NEW ELEMENTARY SCHOOL
9801 HIGHLAND KNOLLS DR
BAKERSFIELD
CALIFORNIA
93306

NEW MIDDLE SCHOOL
4115 VINELAND ROAD
BAKERSFIELD
CALIFORNIA
93306

SHEET TITLE
LIGHTING PLAN
BUILDING F

E-132F
SHEET OF

LIGHTING PLAN BUILDING F

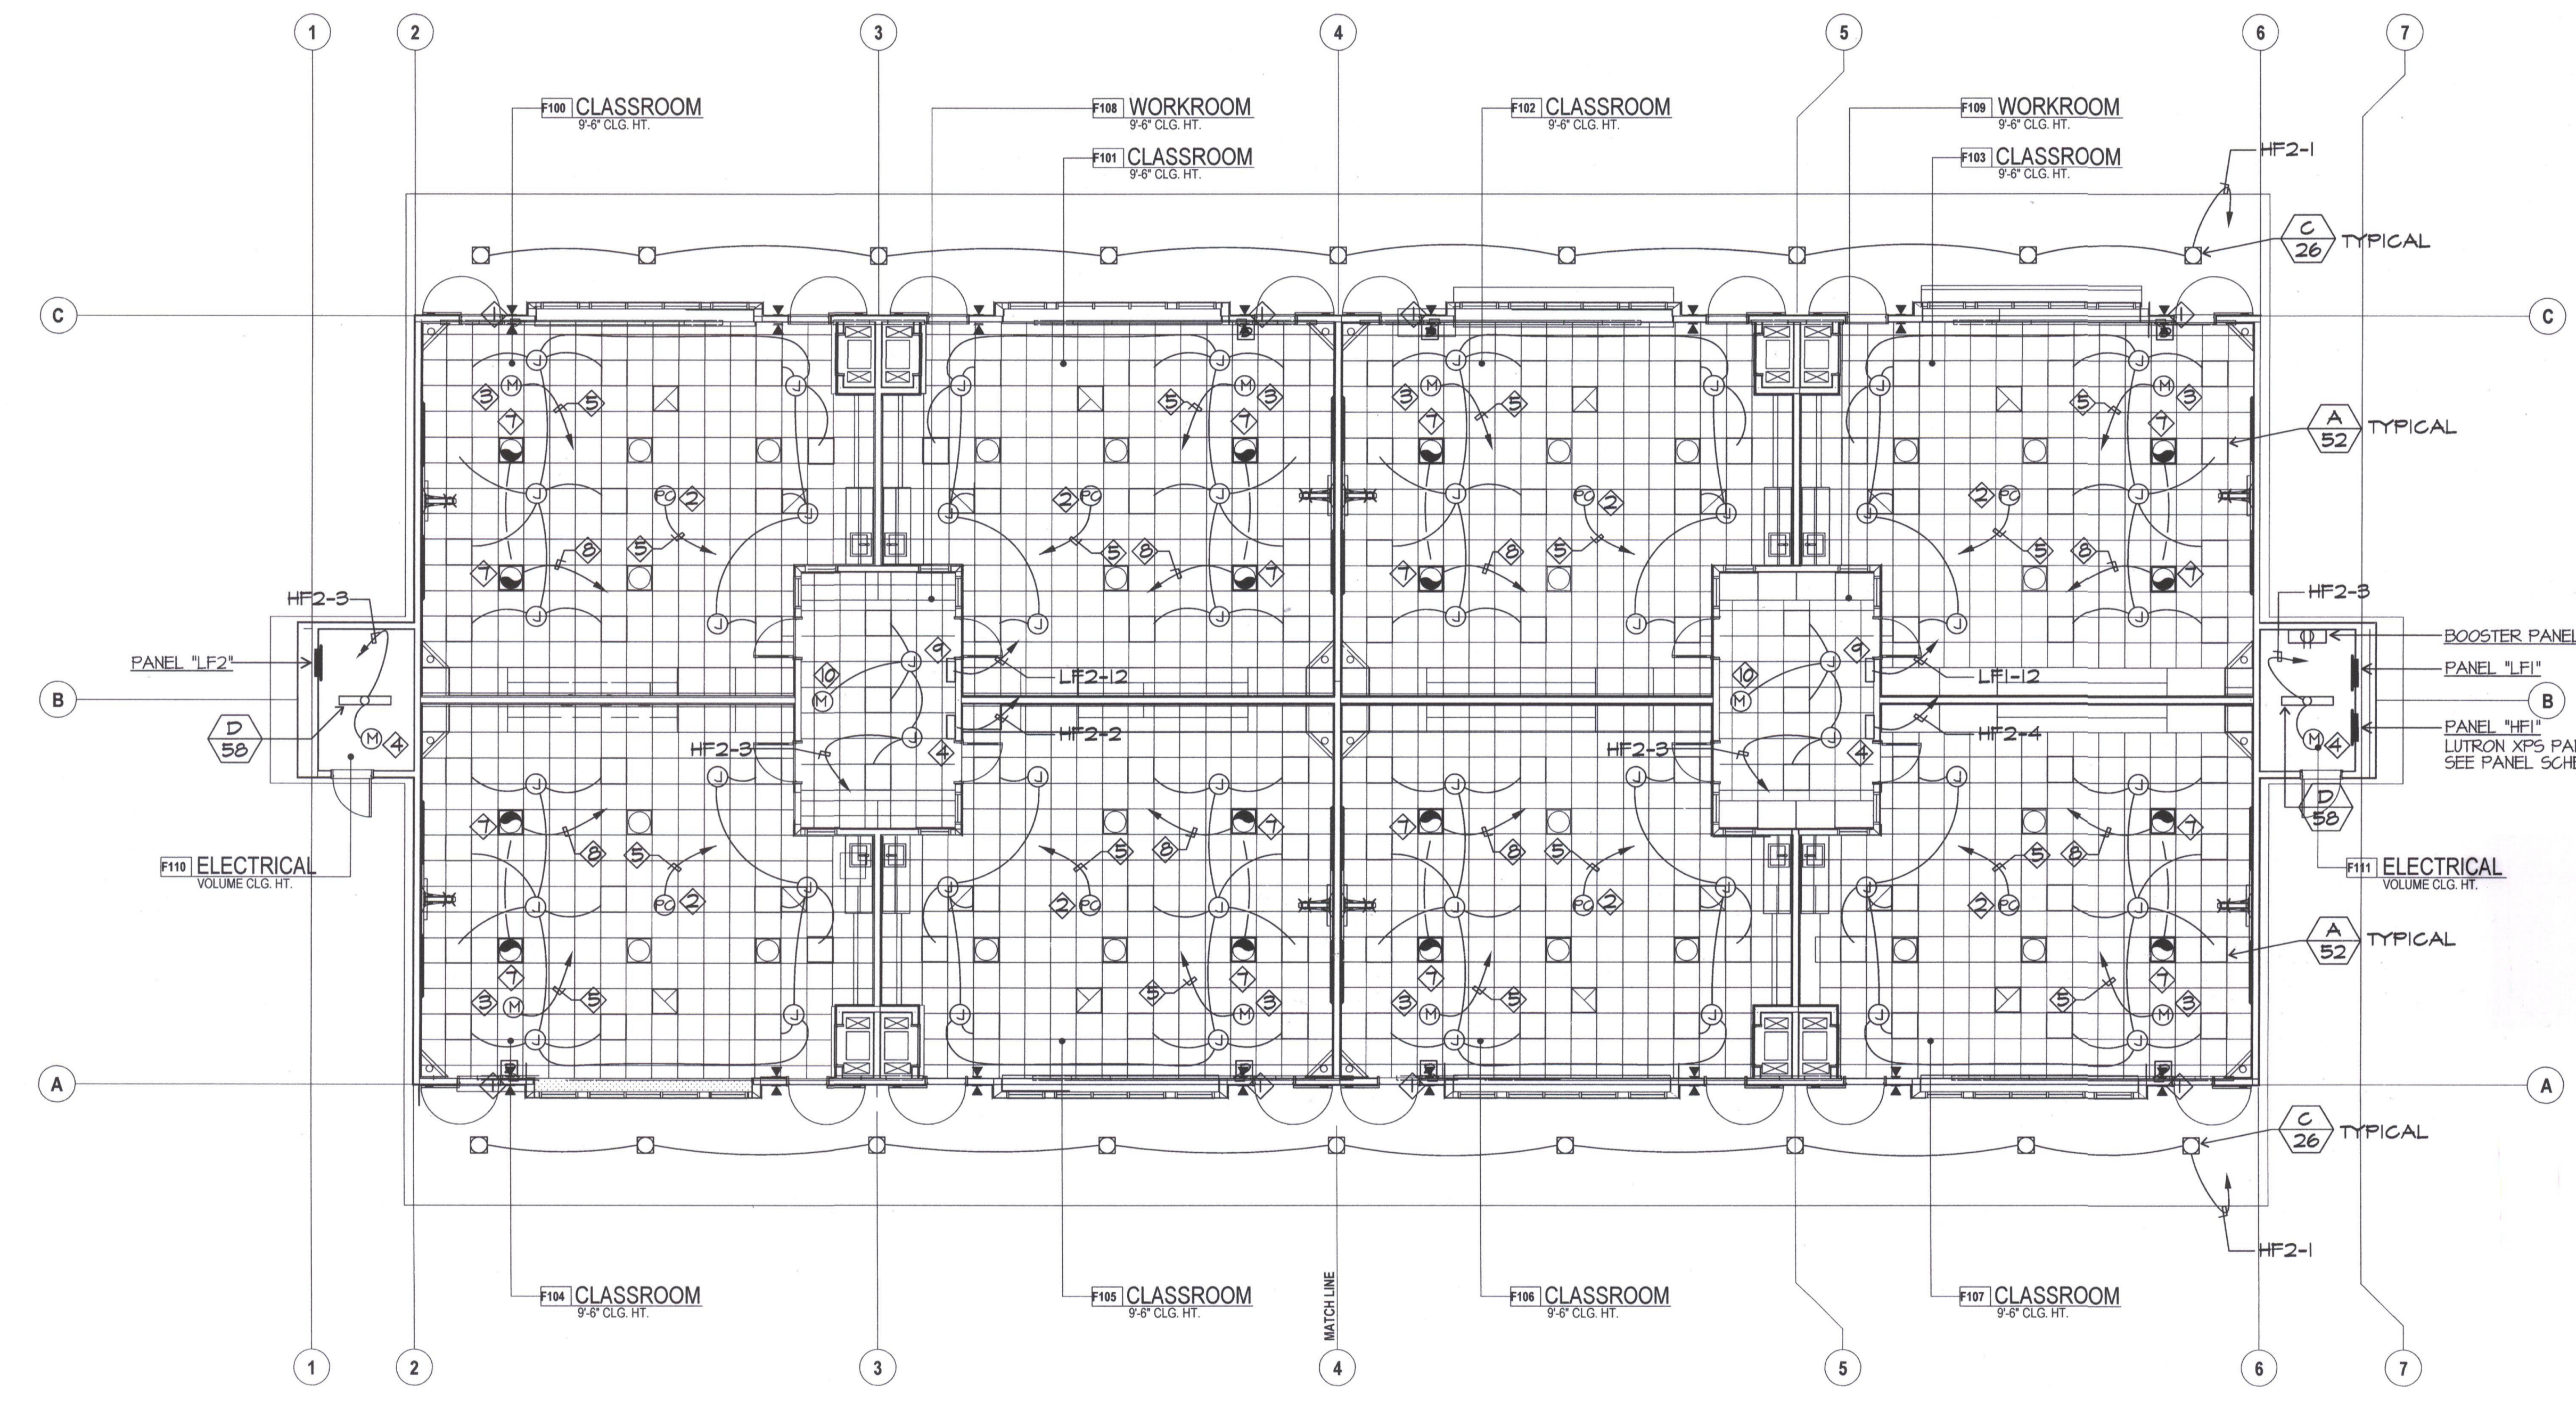
Request:
RDM Electric - 10/9/12
Reference Sheets E-000, E-132C, E-132D, E-132E, E-132F, E-132G, E-132H, E-132P & Lighting Submittal
The General Notes on the Electrical Plans show the lighting dimmers to be installed at 42". A 5-button Lutron wall station is shown to be installed for the lighting controls in the classrooms. Please provide mounting height (elevation) for the classroom lighting control wall stations.

Answer:
Joseph W. Covington - Ordiz Melby (10/11/12)
Install all switches and dimmers at 42" to the center of the box.

Request:
RDM Electric - 9/19/13
Reference RFI #252 & Sheets E-132C, E-132D, E-132E, E-132F, E-132G, E-132H, E-132I, E-132J & E-132P
For the response to RFI #252, the solutions in the classrooms are to be controlled via an Energi Savr Node. However, per the attached cut sheets, the solutions appear to need separate DC switching to be controlled, which is not shown on the drawings. The plans only show to specify DCV to the solutions via the Energi Savr Node. Do the classrooms need DC switching to be added as a means of controlling the solutions? If so, please advise on the requirements.

Answer:
John Maloney - JMPE - 9/19/13
Contact closure on Energi Savr Node will operate solenoid shutter. We verified this with Database and Lutron.
